MAINTENANCE INFORMATION MI12-40

DATE : OCTOBER 2012	SECTION : 06 - Electrical
SUBJECT : LOAD DUMP PROTECTION 50DN ALTERNATOR

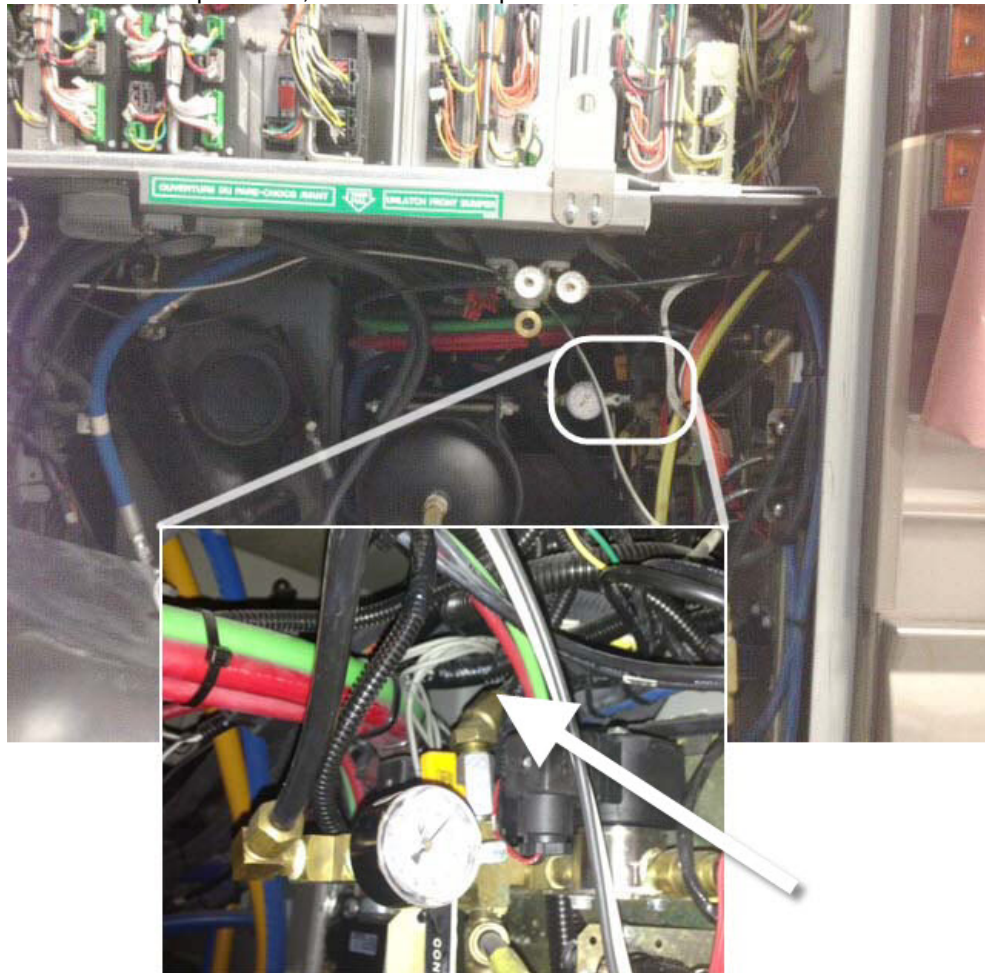
5. At R1 relay, disconnect 85G and cut ring terminal.
6. From pin 86 of R1 relay, run a new 85J red 18ga wire up to SP17.
7. Splice 85J to SP17 using #562228 butt splice and heat shrink tube #562499.
8. Crimp a #560082 ring terminal on 85J, relay side.
9. On existing wire 85G, solder a new diode #561740. Weld and splice other end on wire 85J. Label D62. Protect with translucent heat shrink #562499.

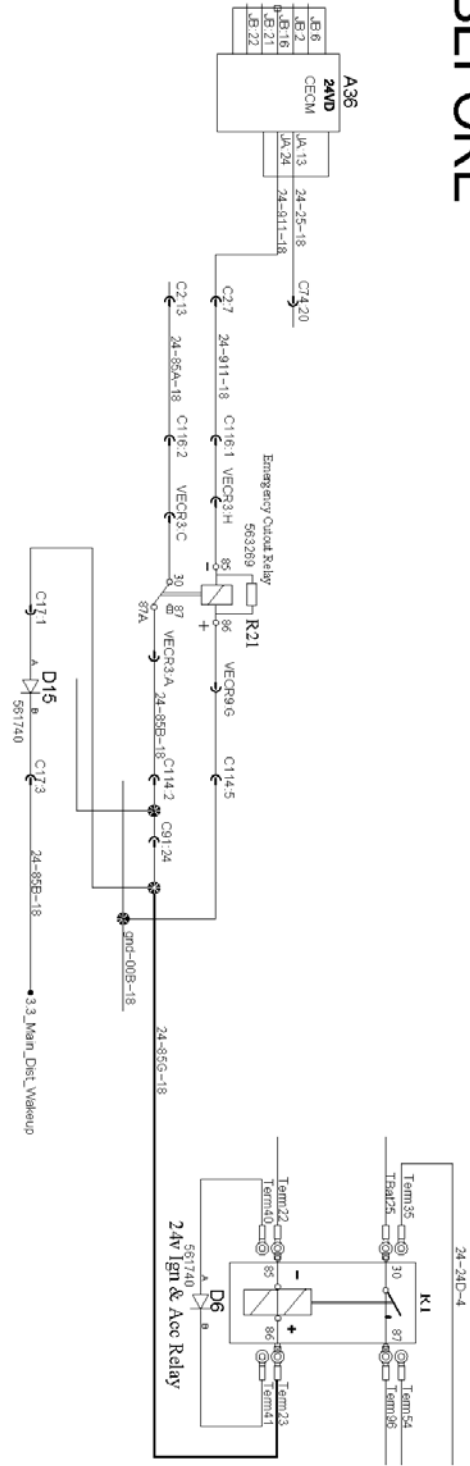
On the vehicles affected, the Delco 50DN alternator may generate a voltage variation when engine is shutting down. A new circuit and a time delay function can be added to the system to provide protection.

Refer to electrical diagram at the end of this bulletin for an overview of the work to perform.
